REPORT TO THE PLANNING COMMISSION & DESIGN REVIEW COMMISSION

SUBJECT: Oakmont Planned Development Phase 4B - Request approval of a Preliminary Site Plan for 14,788 square foot commercial building on 1.89 acres located on Market Boulevard opposite Civic Center Drive and Warwick Willow Lane.

RE: Preliminary Site Plan Application
Oakmont Planned Development, Phase 4b – 14,788 s.f. Retail

PLANTING NOTES

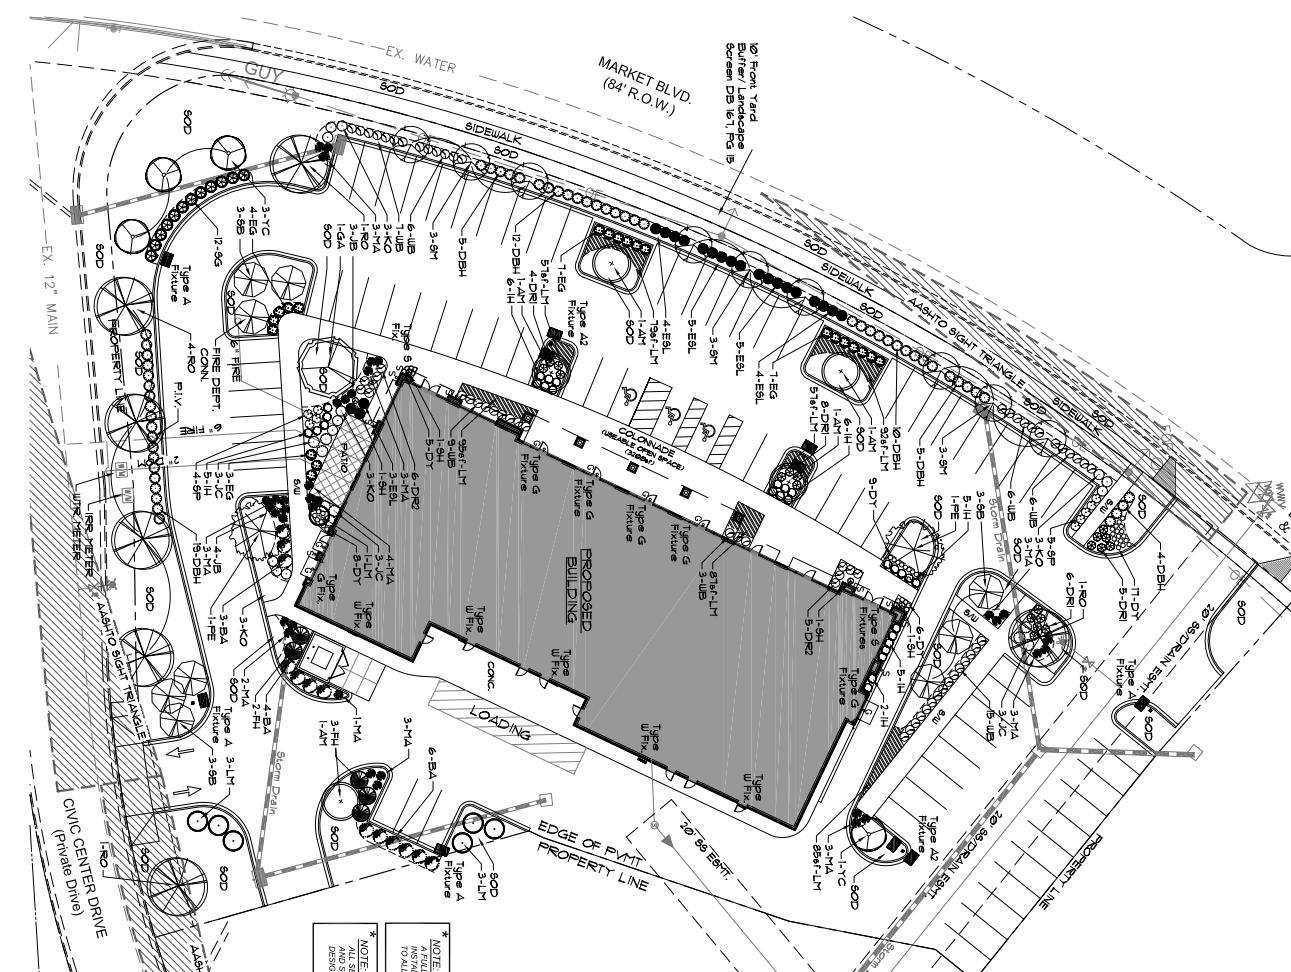
Preliminary Landscape & Lighting Plan (Exhibit 3): The Outline Plan for the Oakmont PD requires a 10-foot landscape area along Market Boulevard. The site is heavily landscaped with tree clusters of small-grwoing evergreen trees and evergreen shrubs along Market Boulevard, a 4.5-foot grass strip, and tall-growing decidous shade trees in the landscaping islands nearest the road (which should not conflict with the overhead power lines). Shade trees surround the property on the west and north. The parking lot islands contain shade trees, flowering trees, and evergreen shrubs. The building foundations are landscaped with a combination of flowering shrubs, ornamenal grasses, and evergreen shrubs. Evergreen landscpaing will help screen the dumpster enclosure (see DRC Condition B) and the loading area from Civic Center Drive, but will not completely screen the “remote wall” that is mostly EIFS (see DRC Conditions E and F).

- M. Since a continuous solid hedge that can be maintained at 42” is required to screen parking lots, close the gap in screening at the intersection of Market Boulevard and the new Civic Center Drive. Low (42 to 48 inches) opaque fences or walls are acceptable design alternatives to enhance the evergreen parking lot screening from view from Market Boulevard.

- P. Provide the required 40-foot front yard buffer along Market Boulevard (D.G. Appendix), overlapping with the 10-foot landscape screen required in the Outline Plan, and increasing the size of Lot #1 if necessary. In the additional planting area created, provide a row of canopy trees to serve as street trees in addition to the evergreen plantings shown in Exhibit 2. If the applicant does not want to provide the

DEPARTMENT OF ENGINEERING
EXTERIOR ELEVATIONS
 COLLIERVILLE, TENNESSEE
 FROM: NA TO: NA DATE: BOOK:
 SCALE: $1/8"=1'-0"$
 DESIGN: RGI DATE: 03/14/00 RGI DATE: 03/14/00

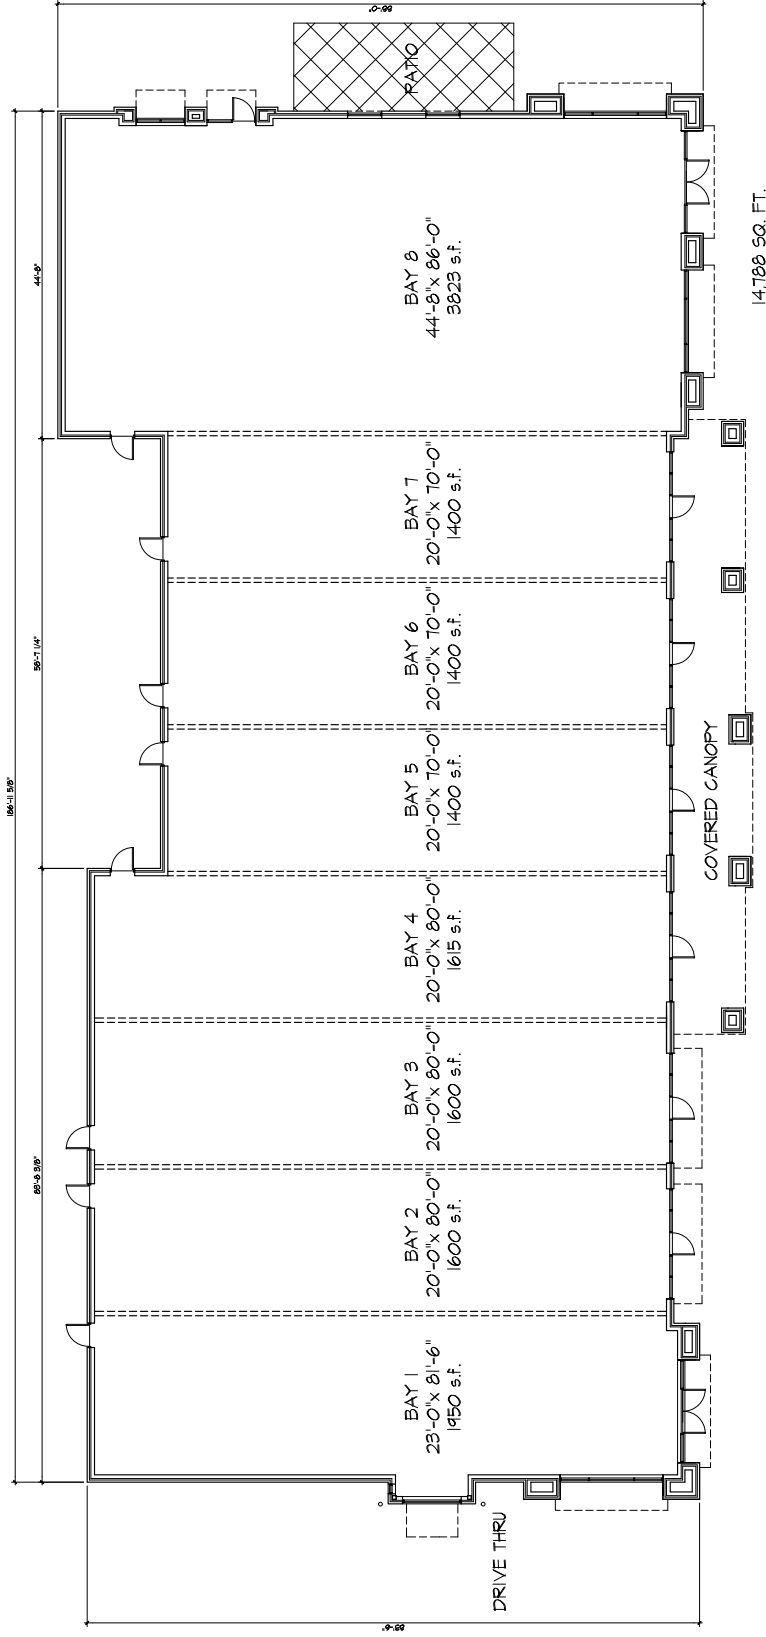
- 1) **Highly Visible Remote Wall:** The east façade is highly visible from the public realm (extension of Civic Center Drive and from adjacent sites) (see Exhibit 2) without proper space for ample buffering, and thusly cannot be considered a "remote wall". EIFS is the primary material on the east side of the building, which is not permitted in such high amounts on visible facades. Although there is a cornice and changing façade planes, the east side less ornate than the other facades. Due to its visibility, brick, a stone base, and storefront details similar to the north and south elevations are needed on the east façade to provide articulation and visual interest (see DRC Conditions E and F).

Preliminary Elevations (Exhibit 2): The primary building materials for the building are four colors of brick, simulated stone, two colors of EIFS (cornice, on towers, at the rear of the building), clear anodized aluminum

storefront, black fabric awnings, and black metal canopies. The applicant is proposing primarily EIFS on the rear elevation facing east and Civic Center Drive, which contains service doors and a loading area. The highly-visible east façade needs to match the materials and design details of the north and south elevations. The use of EIFS as a material other than trim such as the cornice or at the towers is not permitted (DRC Condition E).

Per the Design Guidelines (IV.C.3), for façades facing pedestrian areas “at least 70 percent of the linear horizontal dimension should be covered with windows or doors” and “For secondary elevations visible from streets (south and east elevation) and public areas, storefronts should wrap the corner but do not need to cover the full facade. Facade articulation should continue on these facades.” The west, north, and south elevations appear to meet the intent of this guideline while the secondary elevation (east) does not meet the intent (see DRC Condition F).

- E. The use of EIFS as a material on highly-visible facades is not permitted other than trim and accent, such as at the cornice on the towers (D.G. IV.C.5.). Reduce the amount of EIFS on the east façade.

- F. Include brick columns, tower elements, variation in rooflines, a brick or stone base, and real or simulated storefront elements, on the east facade to provide articulation similar to the north and south facades (D.G. IV. A., B., & C.).
